APPLICATION NO.	FILING DATE	FIRST NAMED INVENTOR	ATTORNEY DOCKET NO.	CONFIRMATION NO.
10/041,833	10/19/2001	David Laverne Sprinkle	DEE6270P0160US	5412
7	7590 12/20/2002			
Polit & Associates, LLC			EXAMINER	
Suite 520 3333 Warrenvi			FISCHMANN, BRYAN R	
Lisle, IL 6053	04		ART UNIT	PAPER NUMBER

Office Action Summary

SPRINKLE

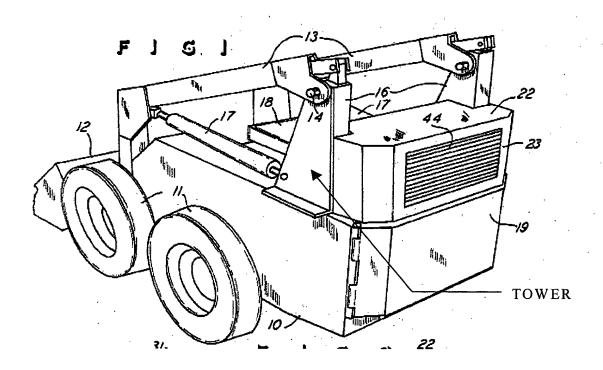
Klee teaches a utility vehicle comprising:

- a chassis (10) supported on wheels (Figure 1);
- a loader bucket (12);
- a pair of towers (see sketch on next page) supported on said chassis and extending substantially vertically (Figure 1), said towers shaped to have outside edges that are further apart

at a bottom thereof an closer at a top thereof (note base of towers on Figure 1 have outside edges that are further apart); and

a pair of boom arms (13) pivotally connected (14) at base ends thereof to a top of each tower, respectively.
